LUFKIN-NACOGDOCHES PROJECT MODIFICATION

**ERCOT Regional Planning Group Meeting
October 15, 2010
Austin, TX**

Lufkin – Nacogdoches Project Modification

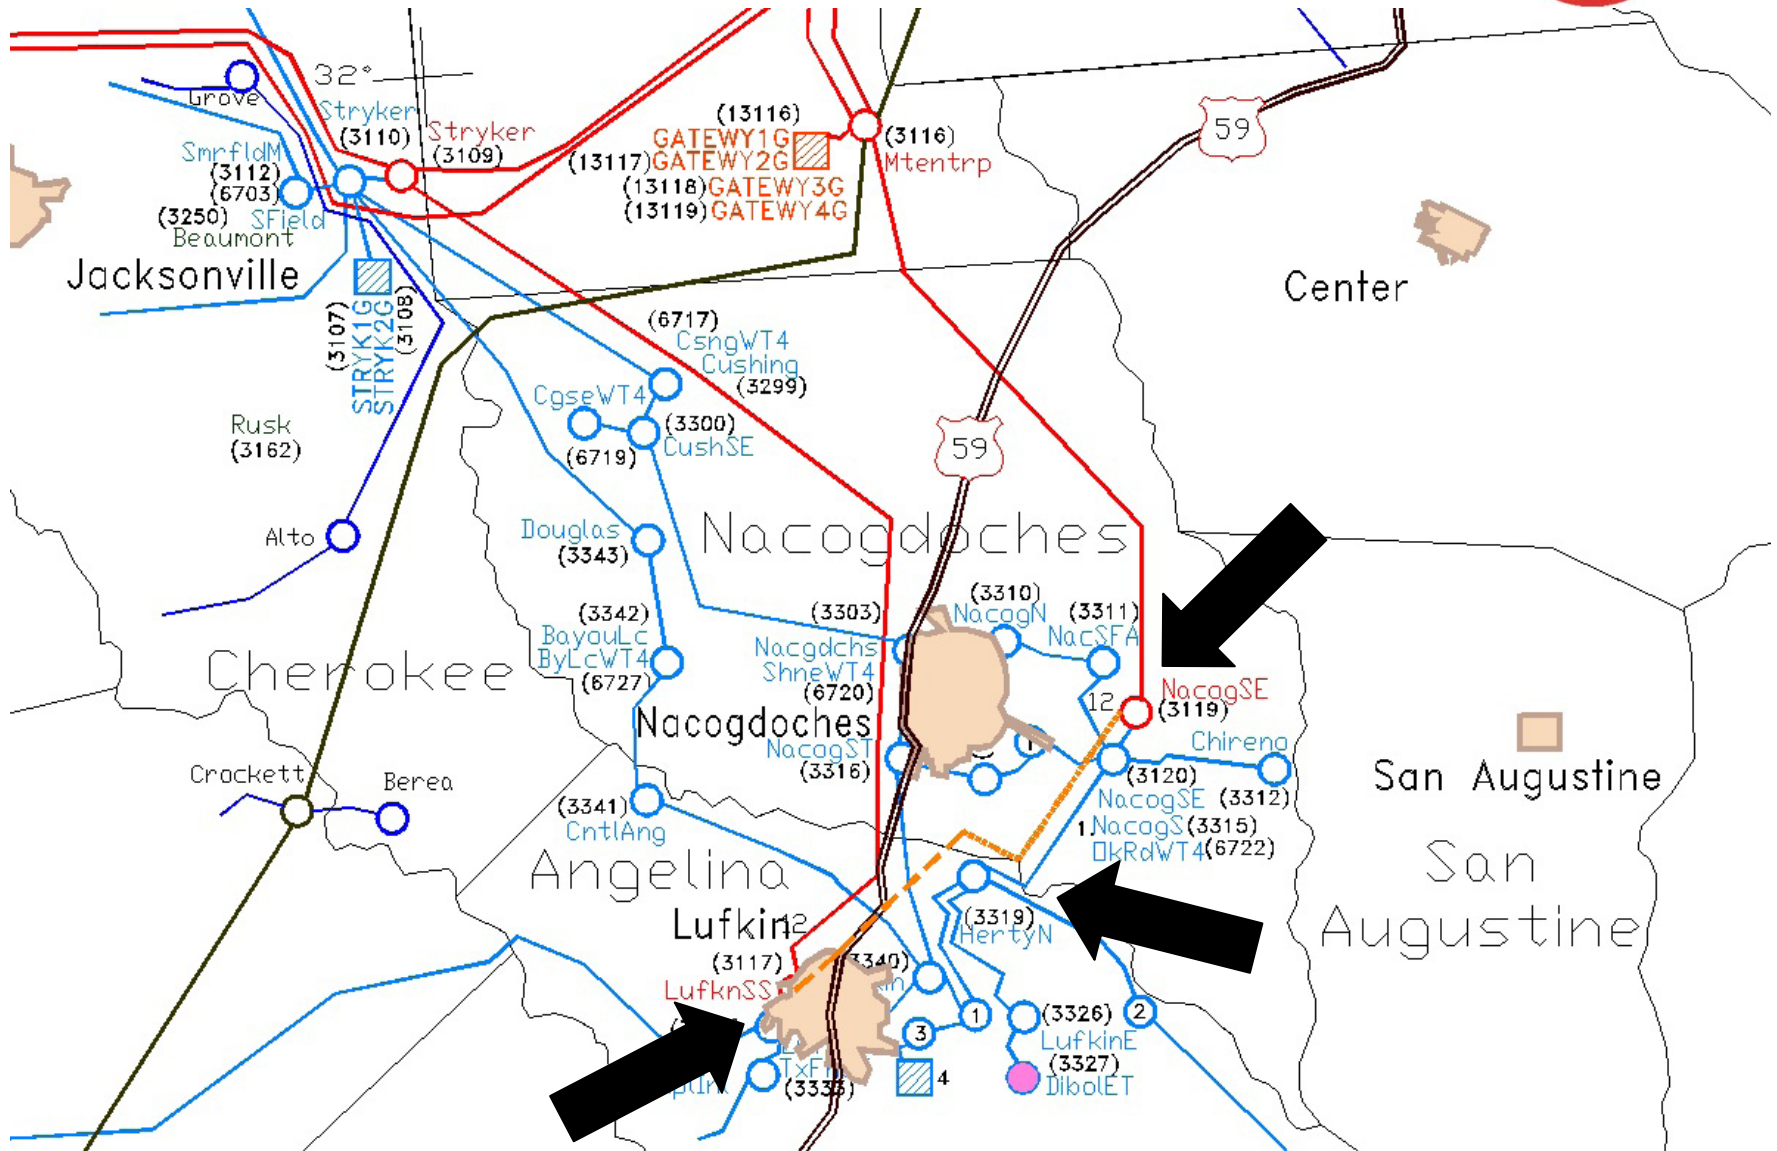
Move existing Mount Enterprise to Martin Lake 345 kV circuit off of the Mount Enterprise to Trinidad 345 kV structures to separate new structures, prevents single tower outage of two circuits (one to two miles)

Upgrade Nacogdoches SE Autotransformer to 600/750 MVA

Delays construction of Lufkin to Nacogdoches 345 kV Line;
good long term solution for area and timed with third
345/138 kV autotransformer for area
